REDEVELOPMENT OF ABBEY WALL WORKS, STATION ROAD
Planning application 19/P4266

A response by Wandle Valley Forum
January 2020

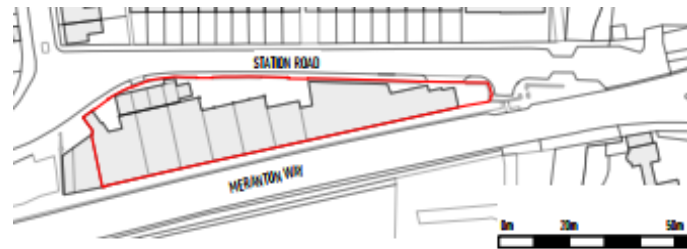
2. Abbey Wall Works is an important location within the context of the Wandle Valley. It occupies a key site in the former estate of Merton Priory, the most significant historic site within the Wandle Valley, and a nationally listed stretch of the Priory Wall forms part of the boundary. The very name of the site recognises its historic role as the main approach to the precinct of Merton Priory. The eastern end is also adjacent to the Wandle river and the Wandle Trail. As can be seen, the boundary of the Wandle Valley Conservation Area was specifically drawn to include this gateway site:

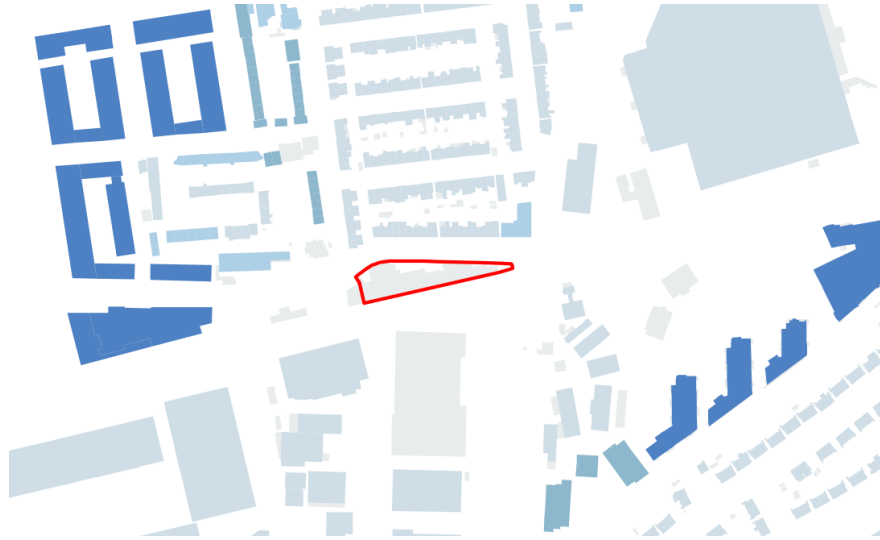
4. We dispute the claim on the application form that the site is more than 20m away from a watercourse. Various documents describe the Wandle as being 25m away when the site location map clearly shows that the middle of the Wandle is less than 20m away from the boundary.
